Planning & Zoning Commission

SUBJECT: Consider approval of a Final Plat for Northwood Trail Plat 1 subdividing 9.25 acres into 32 single family detached townhome lots served by private streets/utilities. The property is located east of NW 70th Avenue and approximately 175 feet east of Peckham Street.

RE: Northwood Trail Plat 1

RE: Northwood Trail Plat 1
Final Plat Review No. 2
Case No. PZ 15-18

NORTHWOOD TRAIL PLAT 1
FINAL PLAT

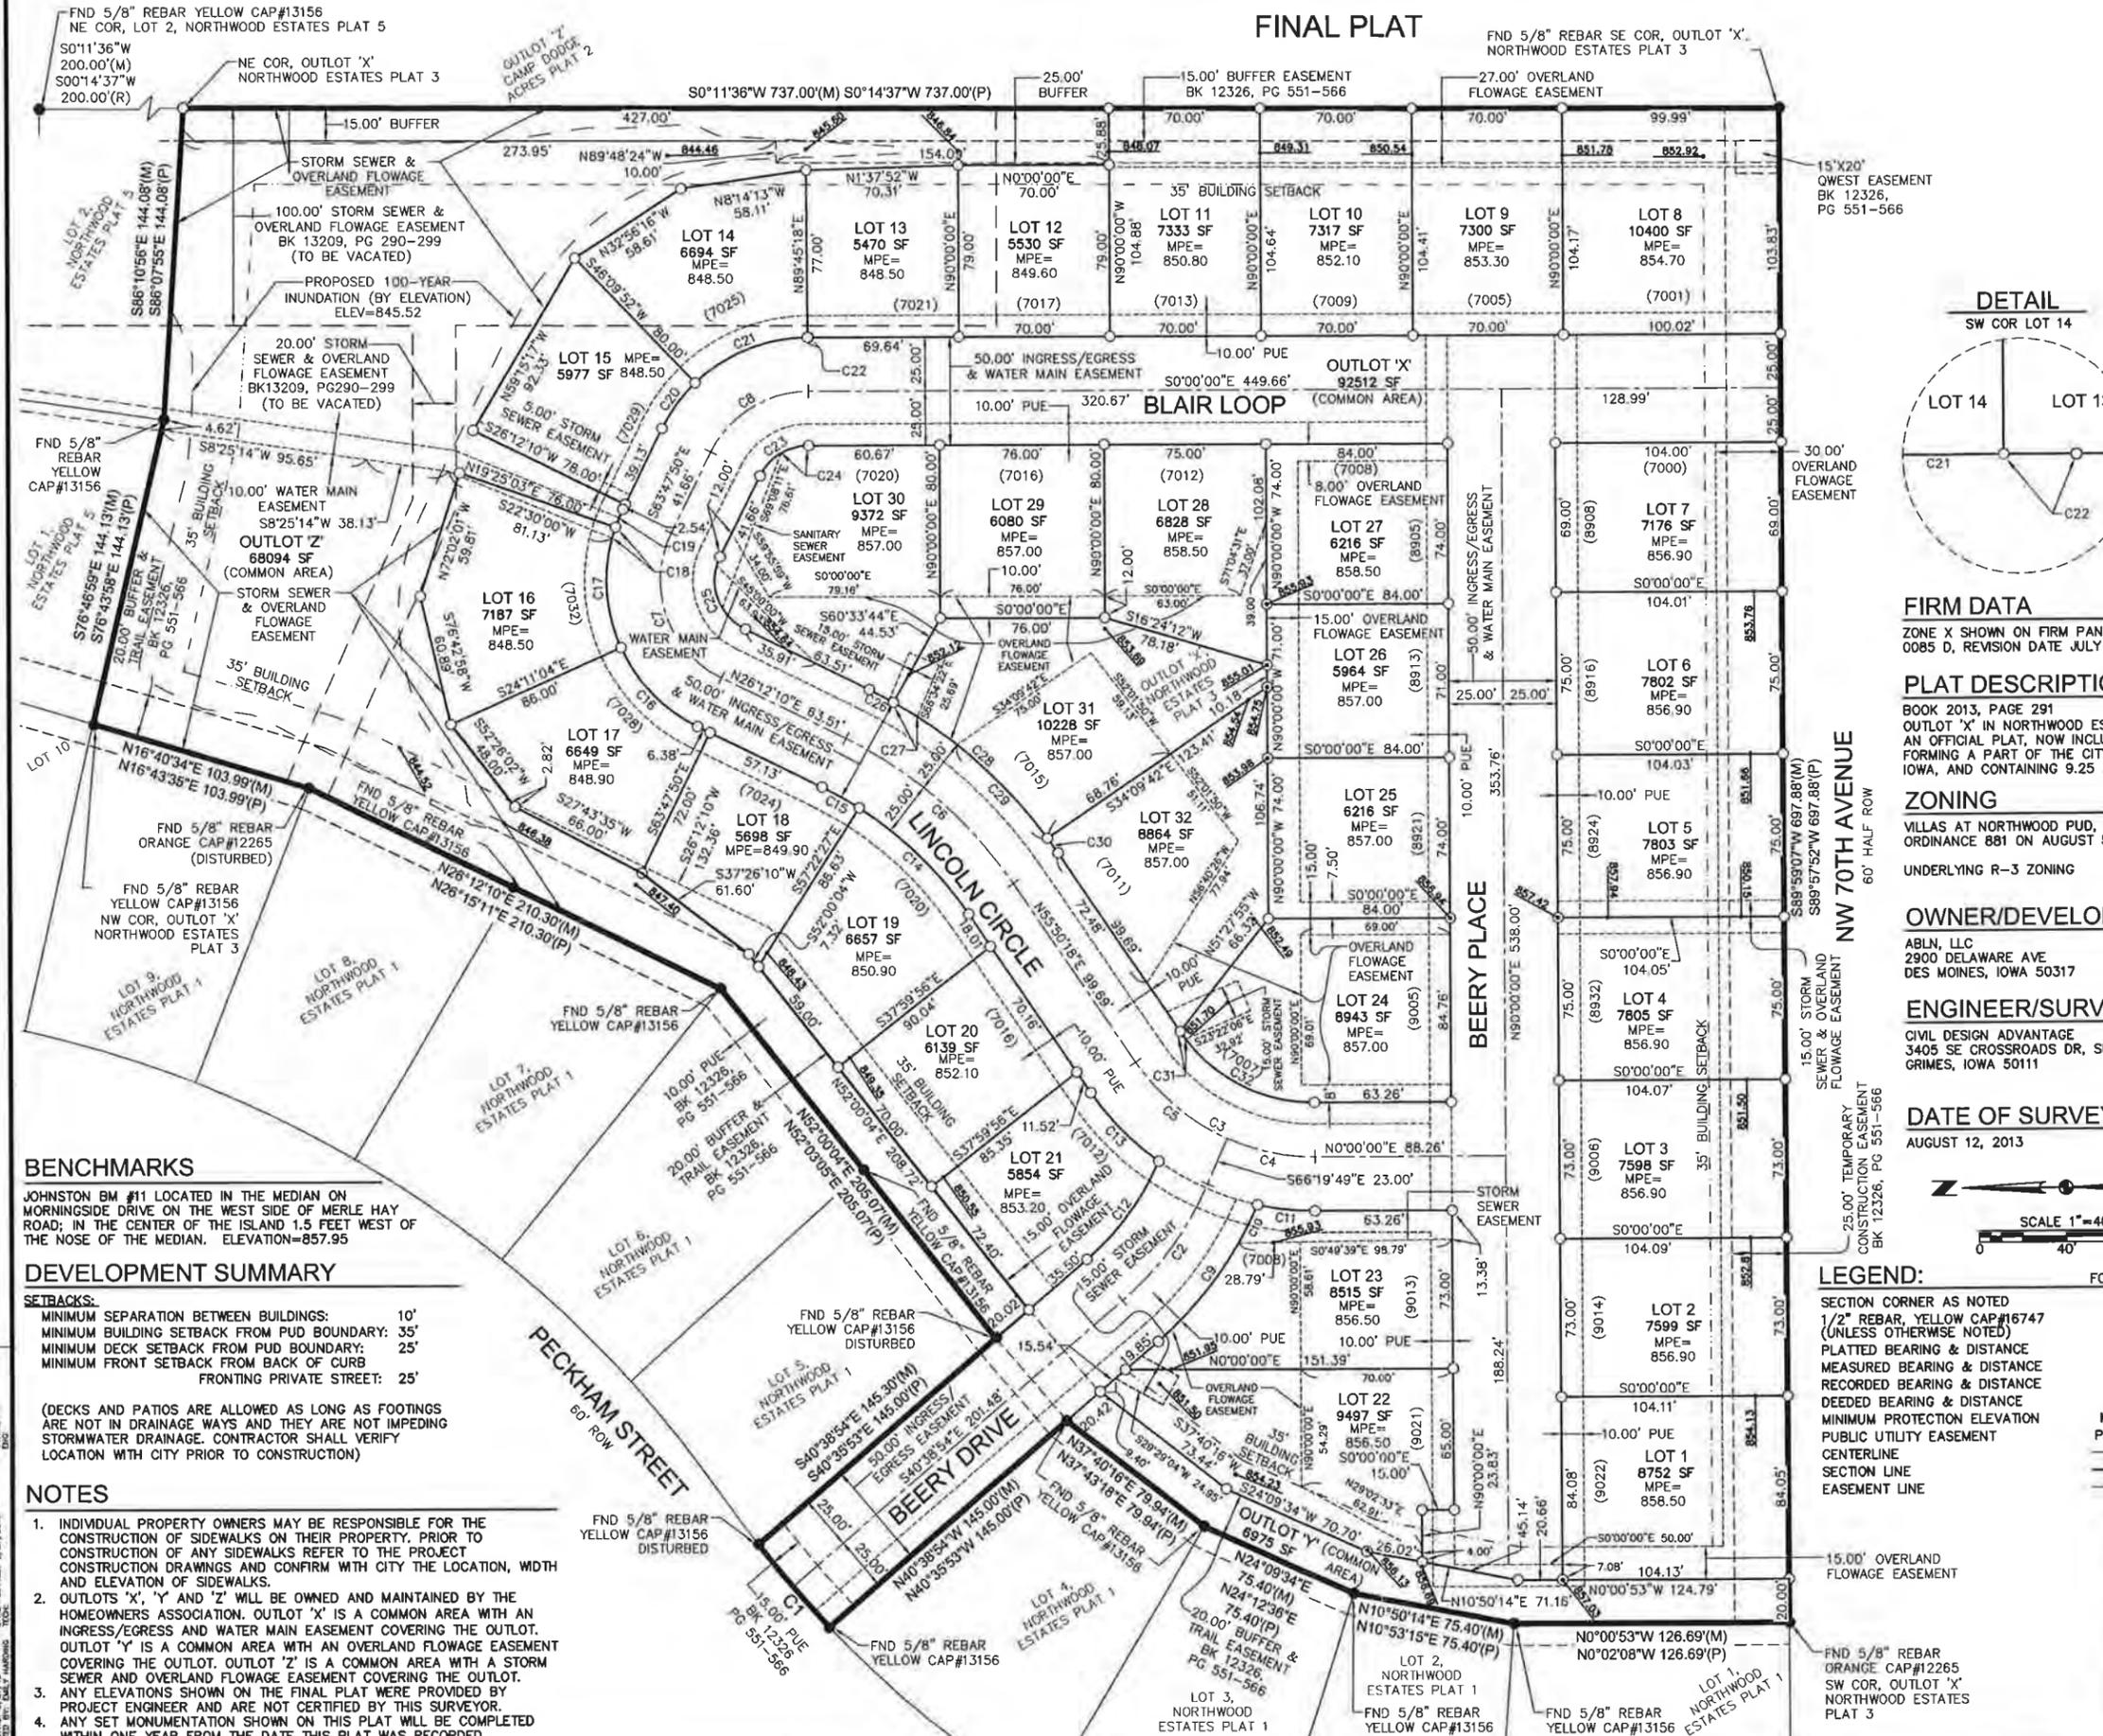
1. Lots shall be addressed according to exhibit provided by staff.
2. Applicant must procure a City grading permit and an Iowa DNR NPDES Phase 2 permit, including a SWPPP for this site prior to any ground disturbing activity.

3. This site is within the Northwest Water Connection District, payment of district connection fees is required prior to City Council approval of the final plat(s). The fee is \$1,750 per acre or \$16,187.50 total for the plat.

4. This site is within the Northwest Area Sanitary Sewer Connection District, payment of district connection fees is required prior to City Council approval of the final plat(s). The fee is \$3,100 per acre until July 1, 2015 or \$28,675 total for the plat.

5. Pursuant to Chapter 180.42 of the Subdivision Regulations and Resolution 08-53, the applicant shall be responsible participation in the reconstruction of NW 70th Avenue to improve the roadway to a collector standard. Prior to the City Council approval of a final plat for the subject property (or any portion thereof) the applicants shall select and provide one of the allowed options outlined in Resolution 08-53 (bond, payment or petition and waiver), based upon the 697.88 lineal feet of frontage on NW 70th Avenue, the 2008 value of this requirement is \$91,820.07. A petition and waiver is attached.

6. Prior to approval of the final plat, the applicant shall provide a financial plan illustrating long-term solvency of a homeowner's association for ongoing maintenance of private infrastructure.
